Village of Bayside  
9075 N Regent Road  
Architectural Review Committee Meeting  
October 24, 2022  
Village Board Room, 6:00pm

## REVISED ARCHITECTURAL REVIEW COMMITTEE AGENDA

Attention:  
Village of Bayside, WI  
Architecture Review Committee

PROJECT/SITE OWNER:	PROJECT SUMMARY:
Elizabeth Plotkin PROJECT ADDRESS: 850 E Ellsworth Ln.	New four-foot wood picket open design fence 221 lineal feet

# Plat of Survey

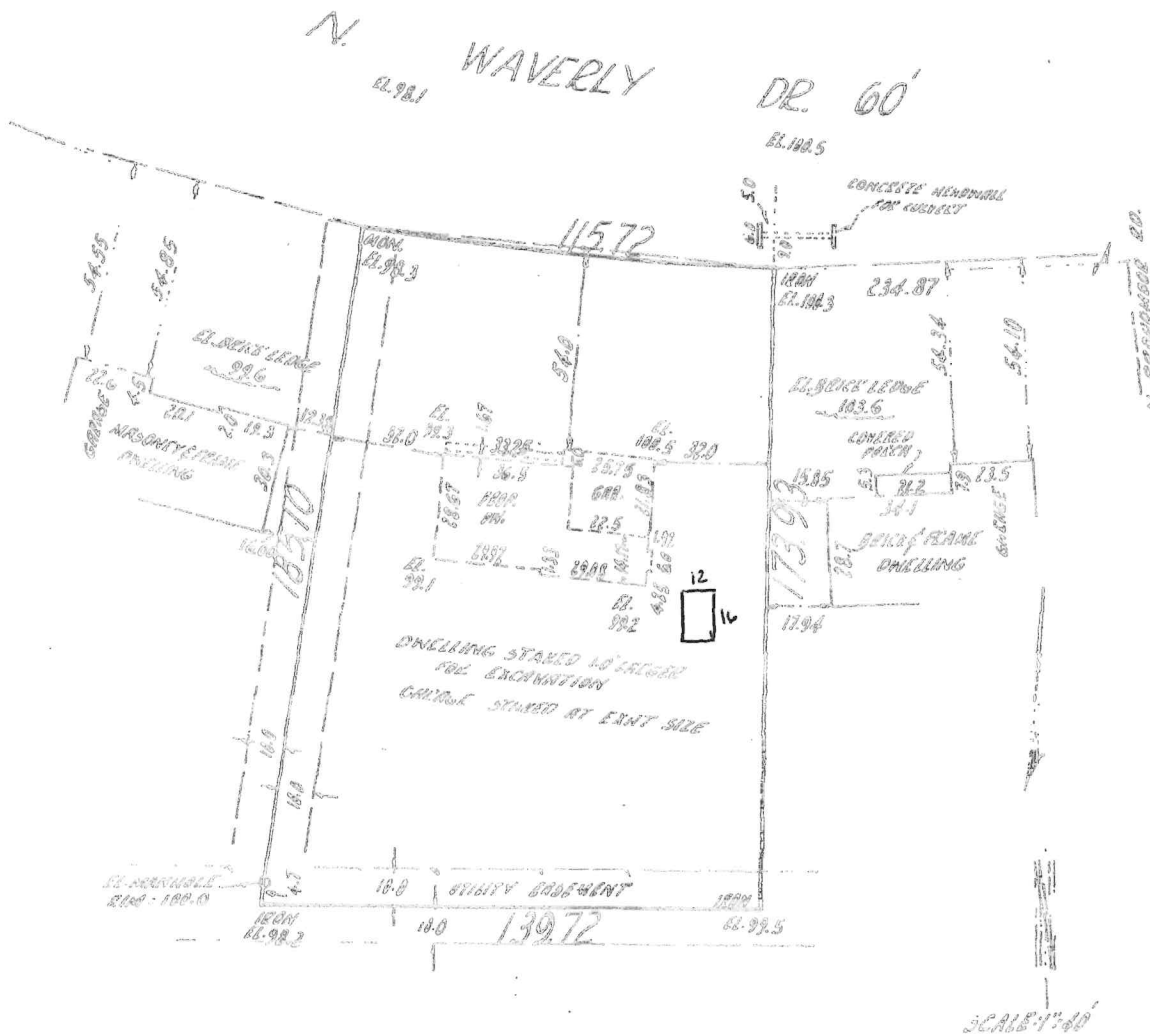
1. Unknown is it Confirms with required setbacks, due to the fact the applicant did not show the set back dimensions on the survey
